## MEMORANDUM

**PROJECT:** Local Advanced Water Purification System

**SUBJECT:** AWPS Canopy Cover

Figure 4. Proposed patterns for AWPS Project

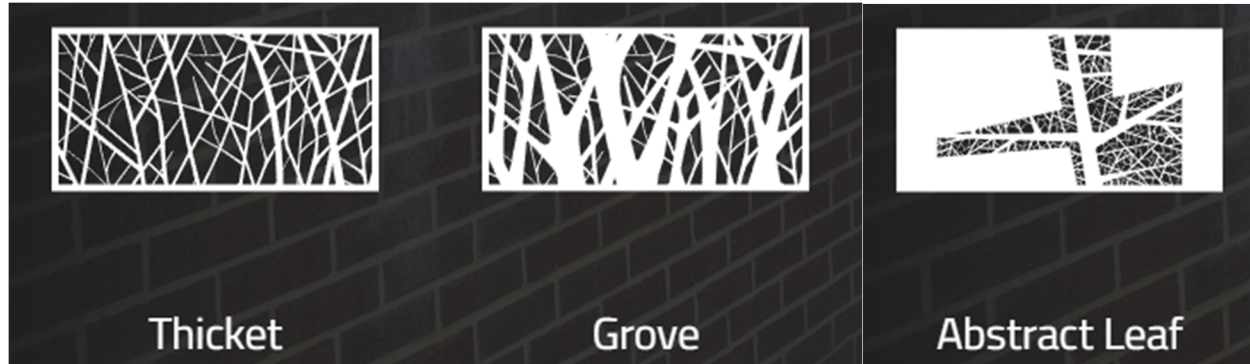
One item for discussion was the possibility of adding screening to the open canopy around the entire building or at least on the side that faces Embarcadero Road (northwest). The City and design team evaluated the feasibility of installing screening on each side of the canopy. For the northeast and southwest faces of the canopy (Figure 1), access is needed to maintain, repair and replace reverse osmosis (RO) and microfiltration (MF) skids. Figure 2 shows sections of the RO skids (green) and MF skids (orange). Full height access will be required during operations; therefore, it is not possible to add screening in these faces. The southeast face of the canopy, shown in green (Figure 1), is located towards the interior of the Regional Water Quality Control Plant (RWQCP), therefore no screening will be provided. Additionally, open access is needed to allow crews remove and replace equipment.

The City and design team evaluated a few options to provide screening to the northwest face of the AWPS canopy. Canopy coverings cannot be installed from the floor to the bottom because access is needed. Canopy screening could be installed from the canopy line down to the top of the electrical building. One proposal is to use functional metal art screen panels. These panels are perforated screen metal sheets and can be used to secure or obscure mechanical or electrical equipment. These panels come in various sizes and are made of steel, cor-ten steel or aluminum. Colors available are white, black, bronze, dark blue, beige, green, orange, red and silver. From the available patterns, the proposed ones are shown below (Figure 4). A few examples are provided below (Figure 5, 6 and 7).
